Joint Development Authority
TCAAP Redevelopment Project

SUBJECT: Consider Recommendation of TRC Amendment Requests

RCC Proposed Amendments - TCAAP Redevelopment Code

Date: March 6, 2026
 To: John Mazzitello, Larina DeWalt – Ramsey County
 From: Eric Fosmo, Michael Kirsch – Kimley Horn

Past RCC (fka TCAAP) Precedence:

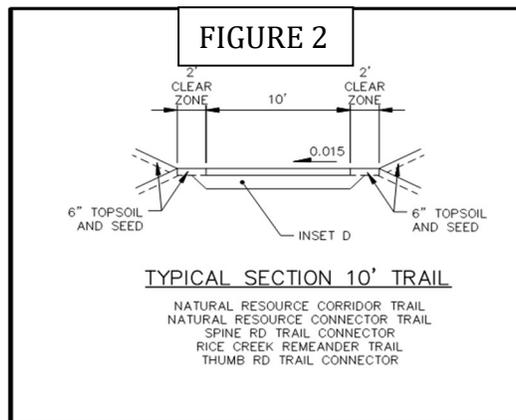
The past design plans, dated 2019, had also planned for 10ft wide multi-use trails throughout the project including all Natural Resource Corridor Trails, Spine Road Trails, and the Re-meander Trail under the future Bridge. See figure 2 for details.

40-ft Vehicular Light Spacing (Per Current TRC)

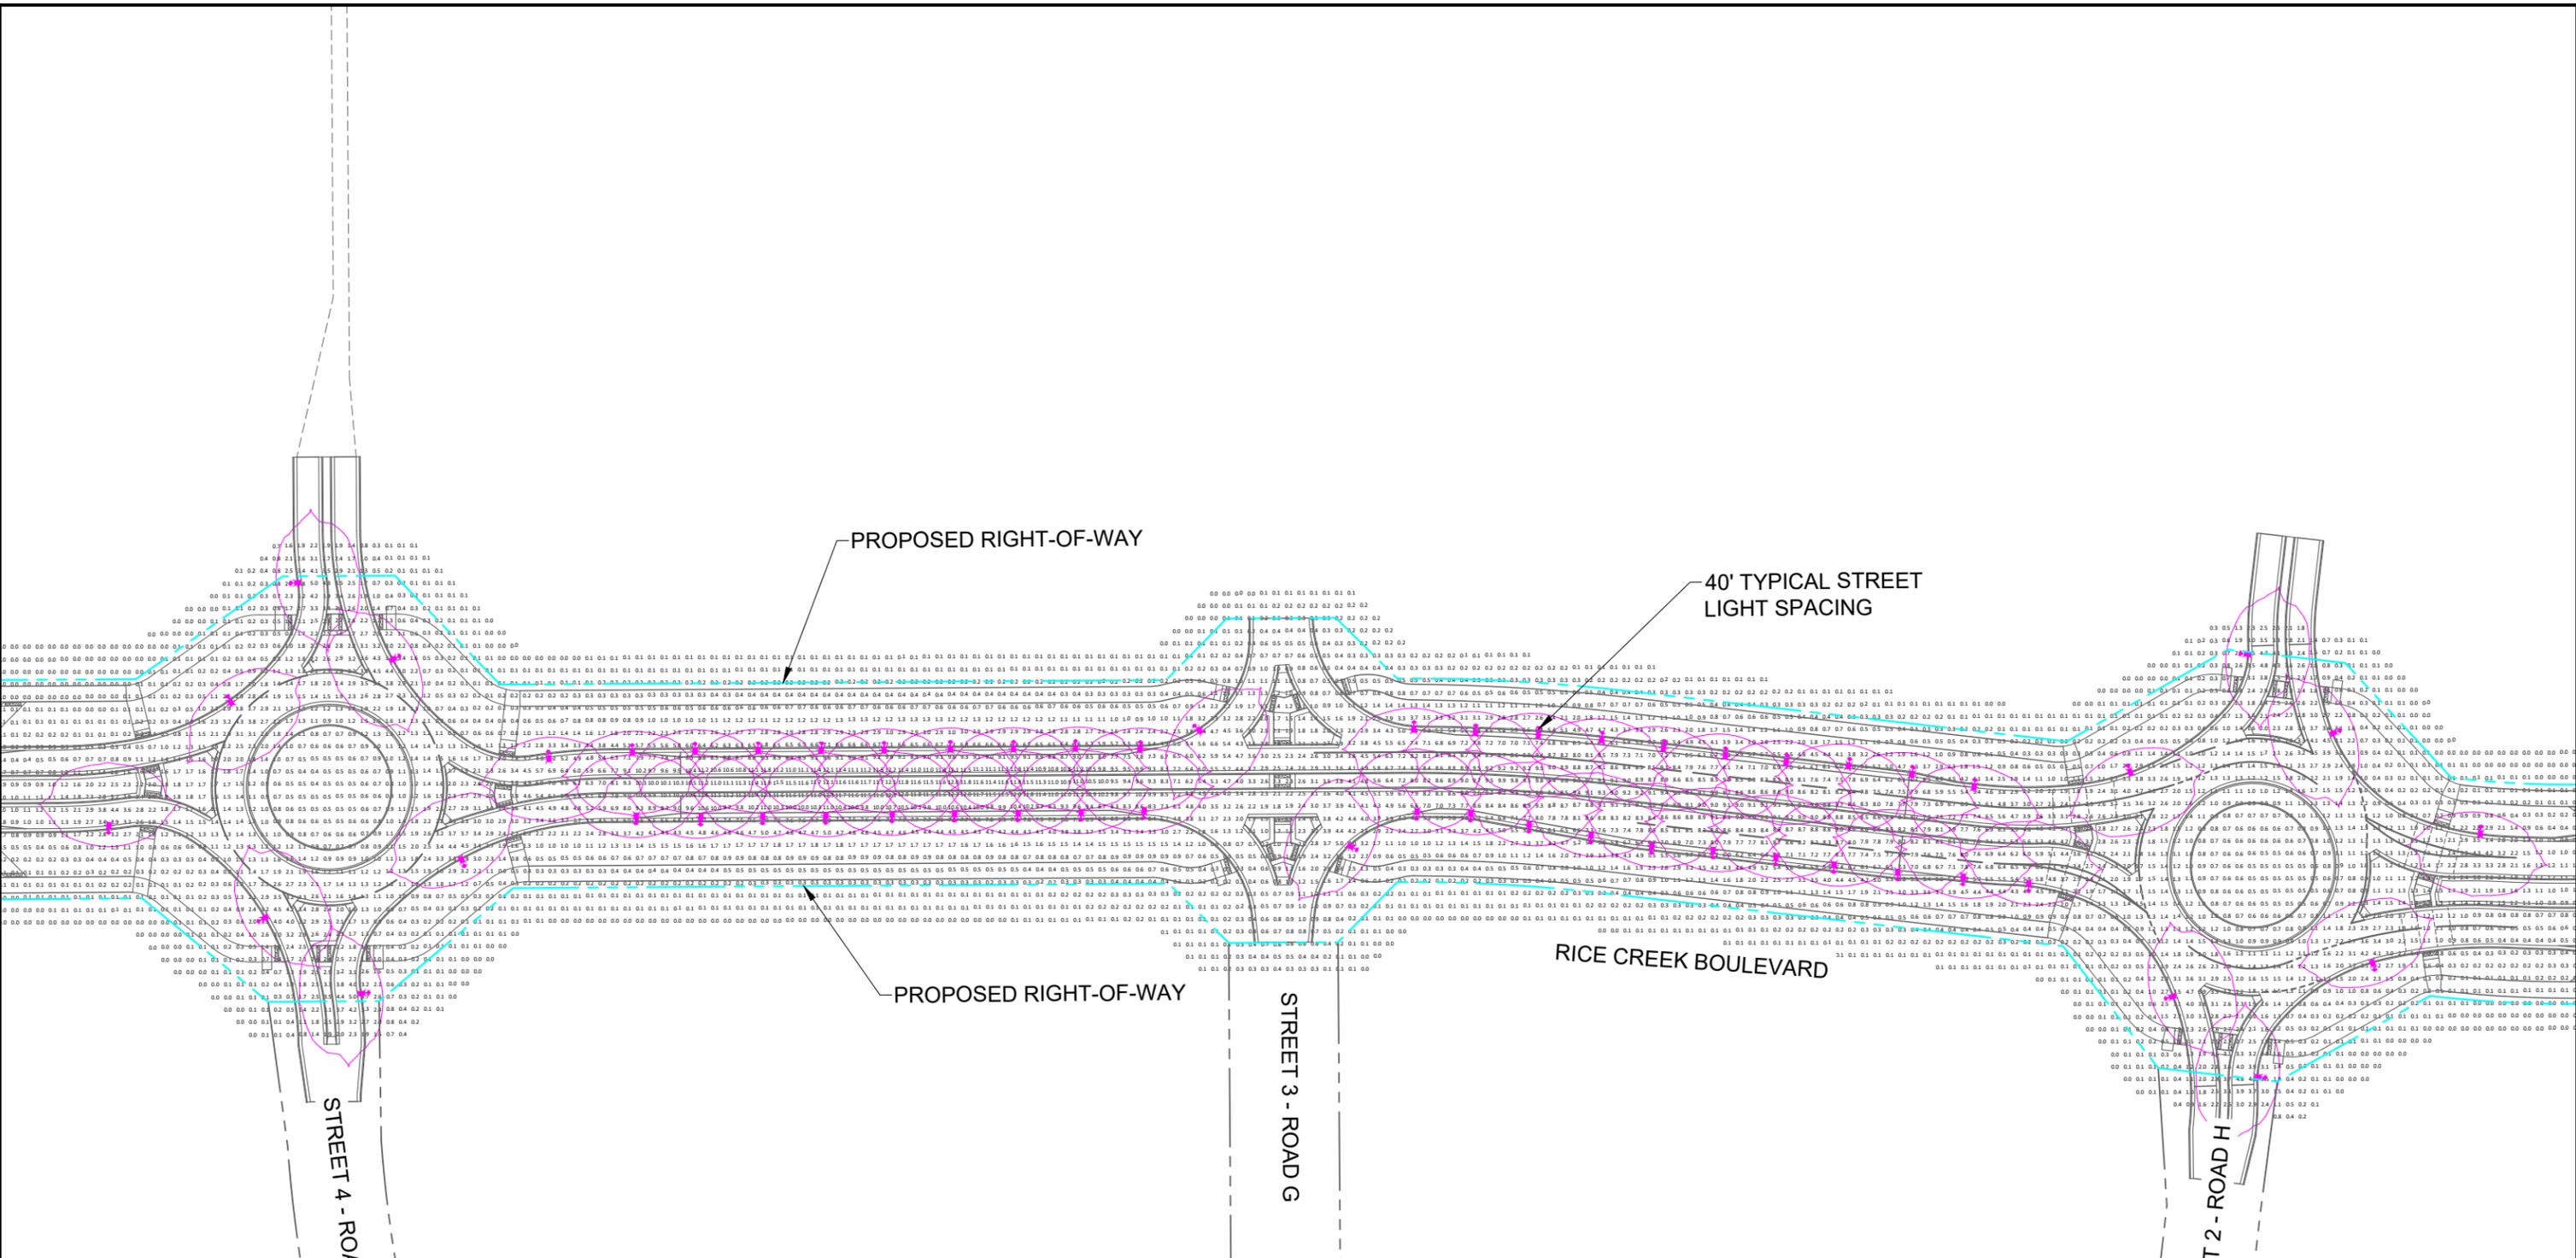
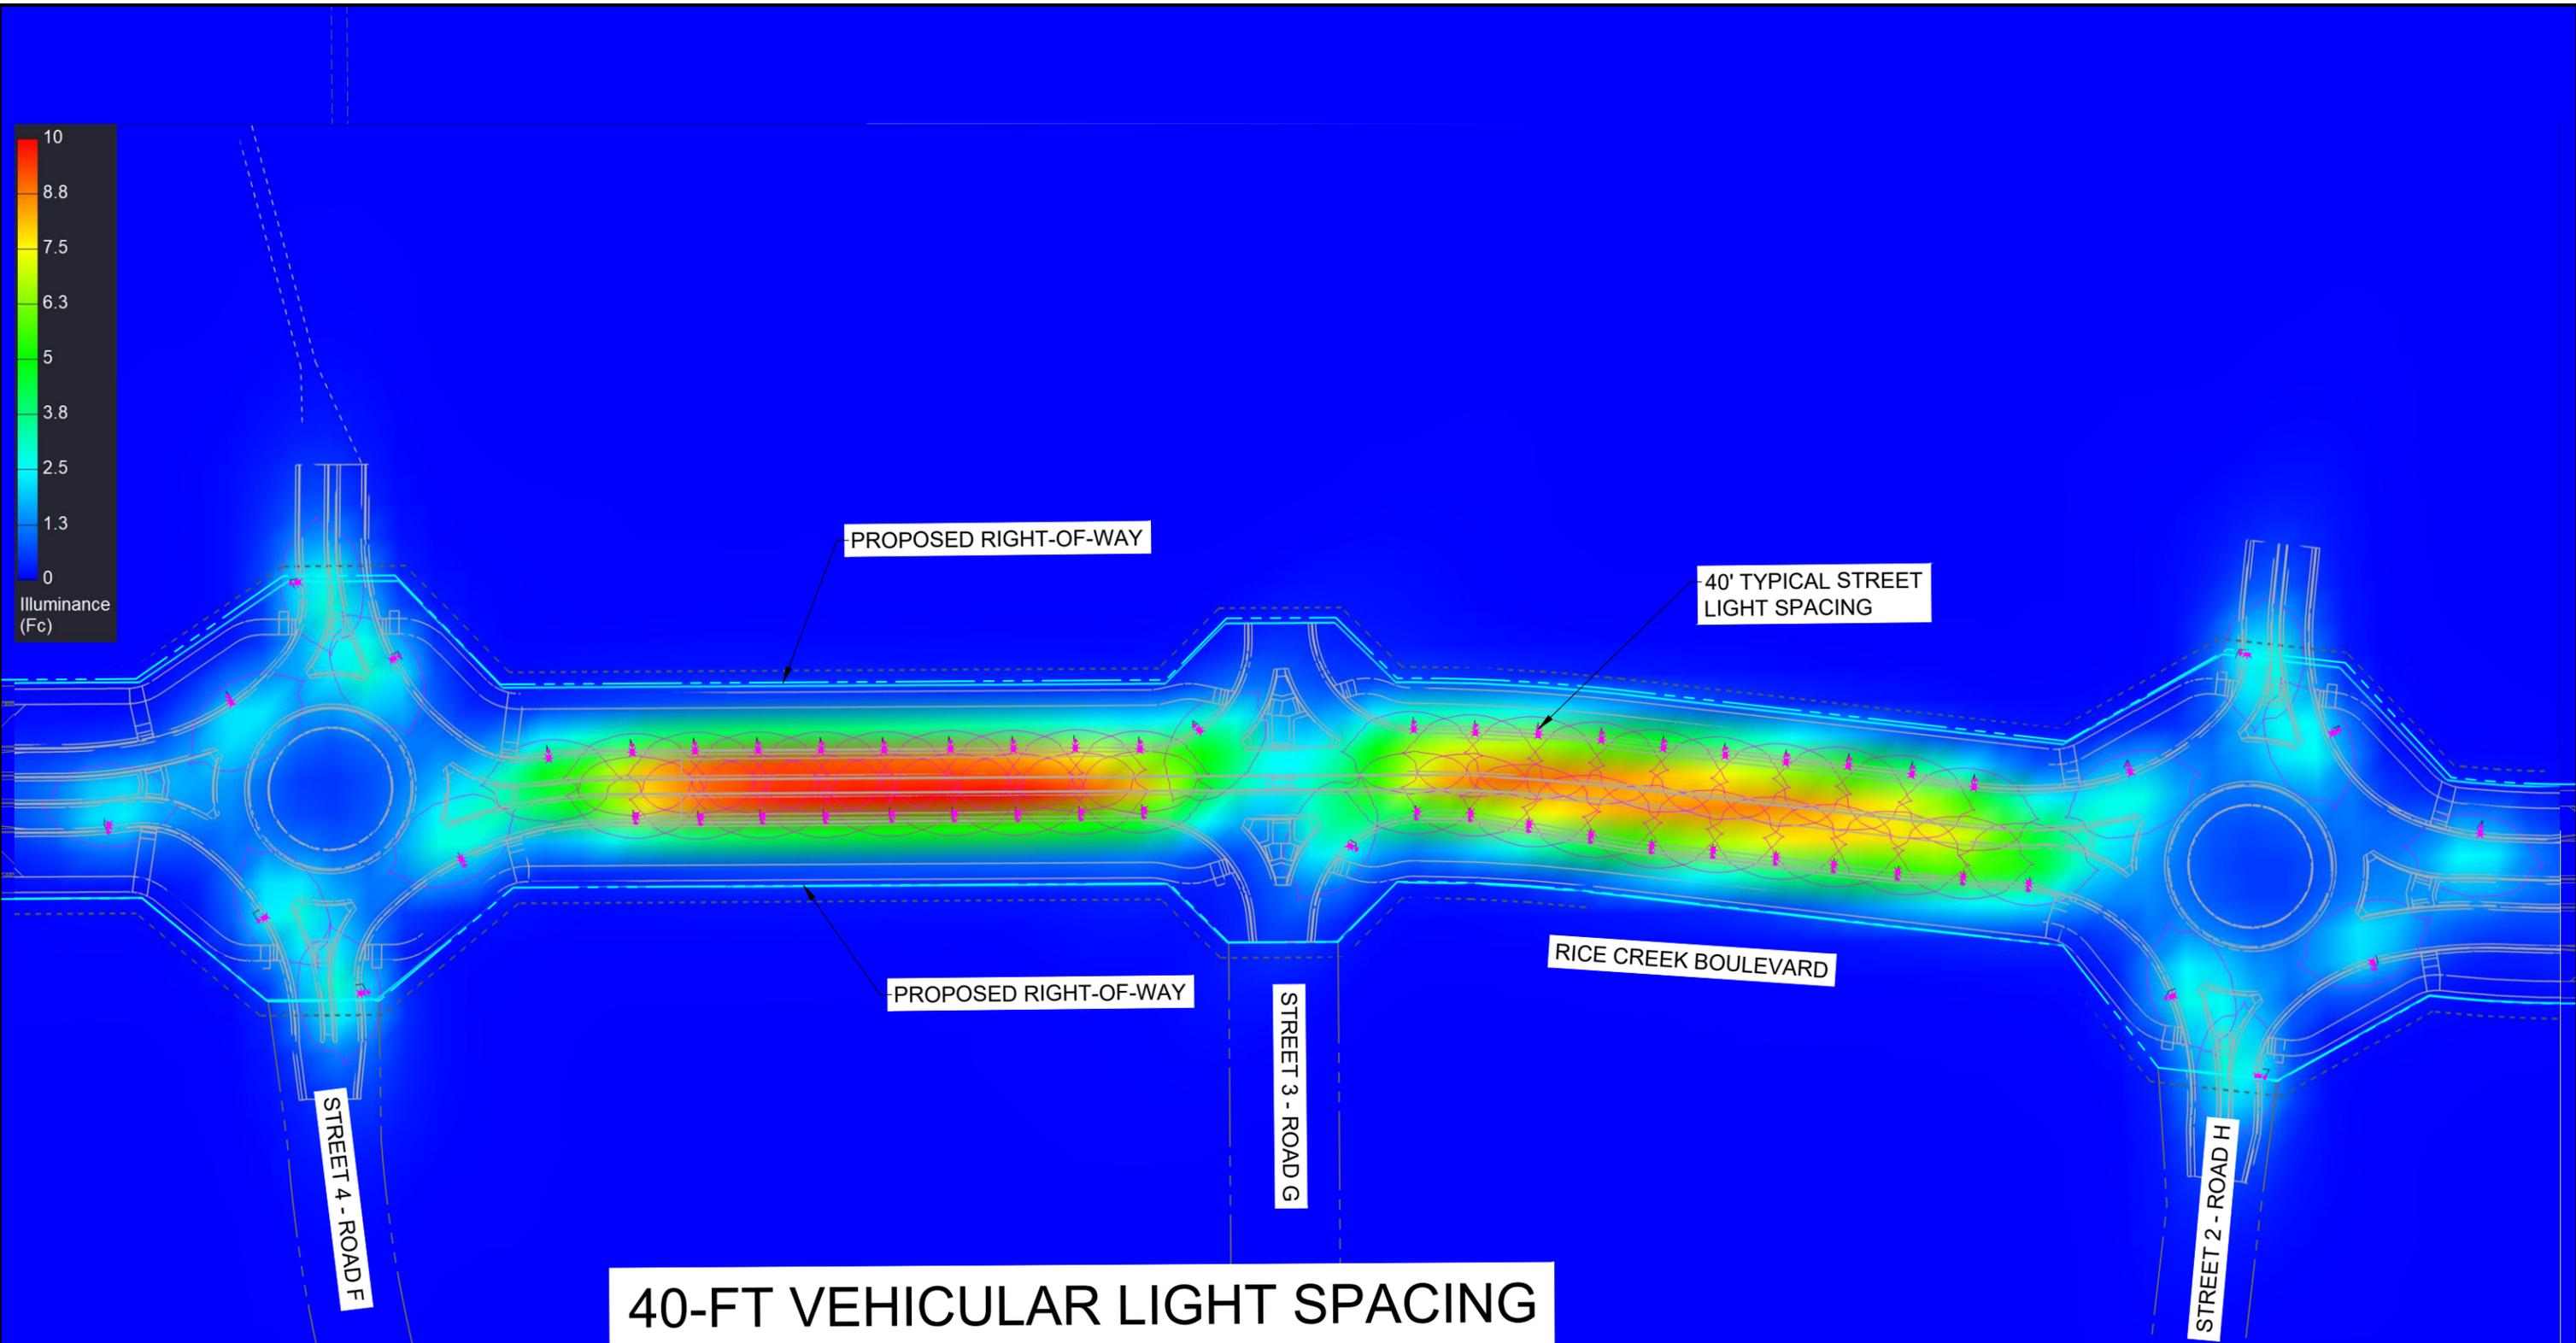
- (a) Vehicular lighting shall be a maximum of thirty feet (30’) in height and pedestrian-oriented lighting a maximum of eighteen feet (18’) in height.*
- (b) Streetlights shall be placed at an average of forty feet (40’) on center, approximately three (3) feet behind the back of curb, aligned with street trees, and where street trees are planted.”*

As written, the applicable code appears to allow for an approach where no lighting would be required along Rice Creek Boulevard. However, this approach would not be consistent with best safety practices nor City/County design precedence at the proposed roundabout intersections. The need to provide intersection lighting does not allow for compliance with the TRC through providing no lighting along Rice Creek Boulevard.
